ORIGINATION FORM

Proposed Revisions to a Standard Plans Index
(Please provide all information — Incomplete forms will be returned)

Index Number: 455-124

Index Title: 24" CFRP & SS Prestressed Concrete Piles

SPIRAL TIE ELEVATION

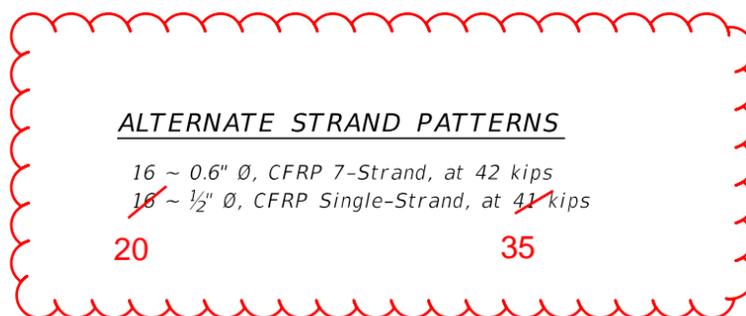
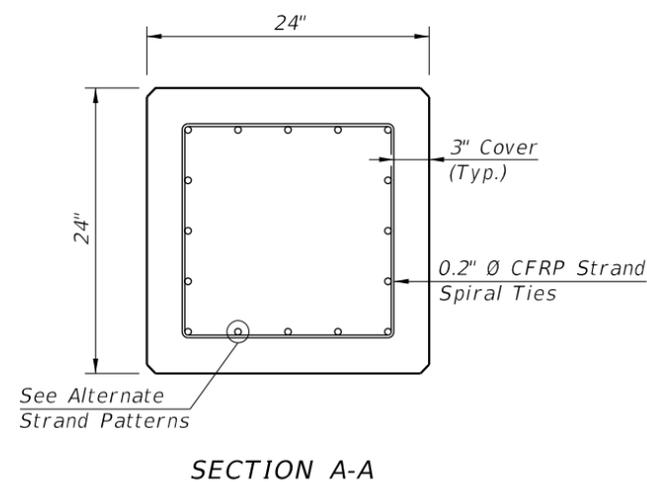
Sheet 1: Changed 0.5" CFRP strand layout; Sheet 2: Added 0.6" HSSS strand
